Swedish viewpoints on the 'centilong' classification

Swedish CRS expert group, involving:

Comment to the NL contribution on conversion to "Centilong groups"

Stature as a function of age (median, 5 and 95 percentile)

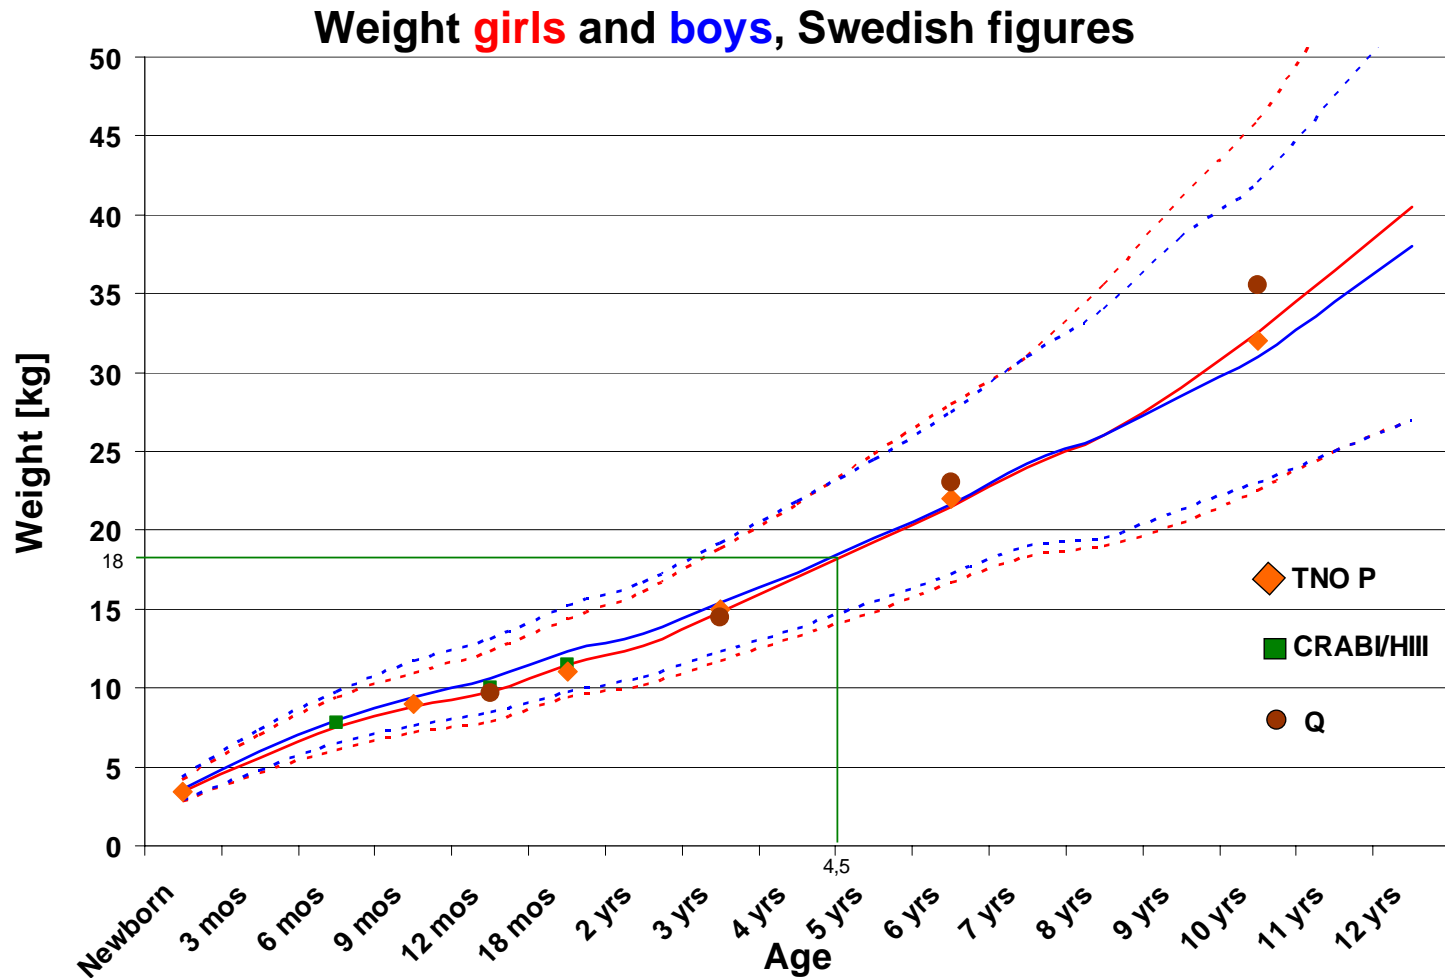
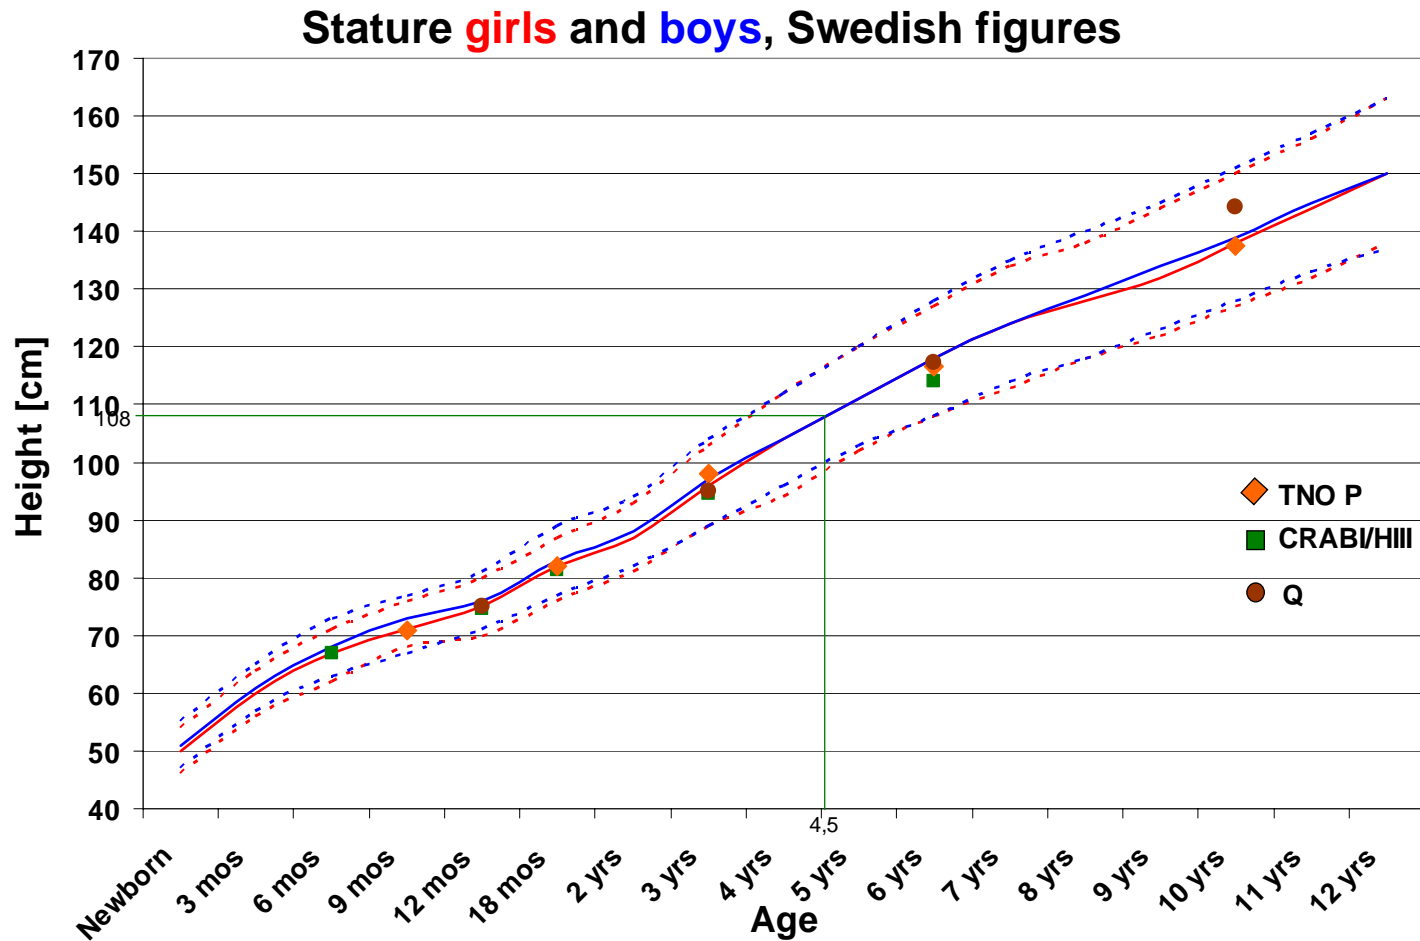
Observations/conclusions

- The upper limit for the current ECE Group 1 (18 kg), corresponds to a median age of 4,5 years (span from 3 to 6 years)
- The corresponding stature (Swedish data) is
 - median: appr. 108 cm
 - 5 percentile: appr. 98 cm
 - 95 percentile: appr. 115 cm
- These values match the CANDAT data well, e.g.:
median for an 18 kg child is 4,5 – 5 years old, stature is 107-110 cm

- According to the NL proposal, the Centilong Group corresponding to ECE Group 1 (the largest group allowed with integral belts) is suggested to be in the range of 74 – 98 cm.
- This upper limit corresponds however to a child mass of only 15 kg, or the actual mass of a P3/Q3 dummy.
- The current ECE Group 1 limit is 18 kg, corresponding to a median stature of approximately 108 cm.
- 60 % of children 3 - 3,5 YO and 28 % of children 3,5 - 4 YO travel rearward facing in Sweden; their statures are up to approximately 108 cm. The restraint class must include these children as well.
- **Consequently, the Swedish opinion is that the new "integral centilong class" must cover a stature of at least 108 cm.**

Folksam study of rearward facing travelling in Sweden

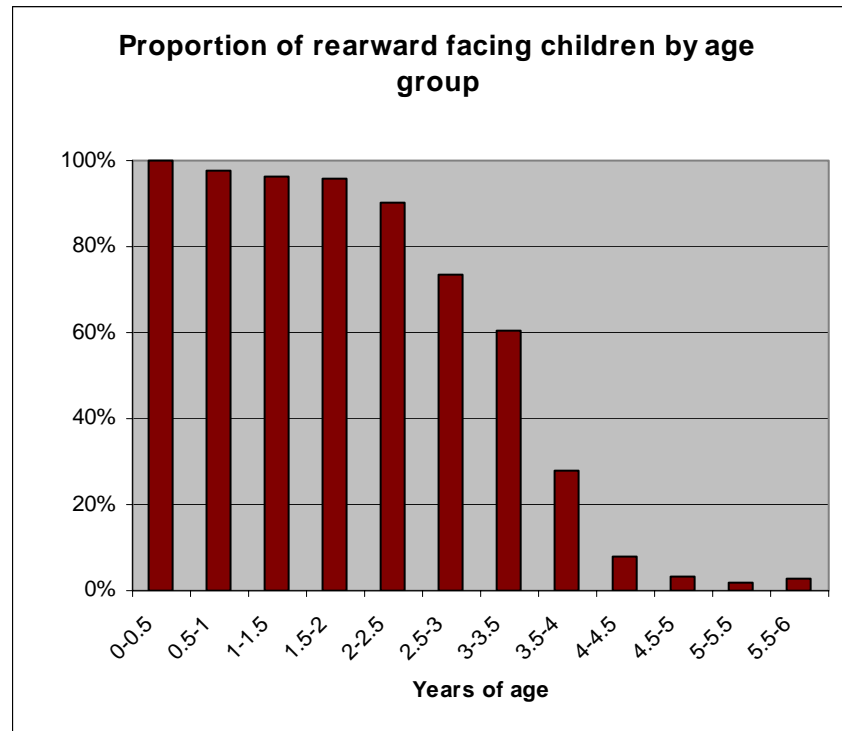
Main conclusions:

- Age 3 – 3,5 years: 60 % travelling rearward facing
- Age 3,5 - 4 years: 28 % travelling rearward facing
- Age 4 – 4,5 years: 8 % travelling rearward facing
- A few children of age 5,5 years are still rearward facing (!)
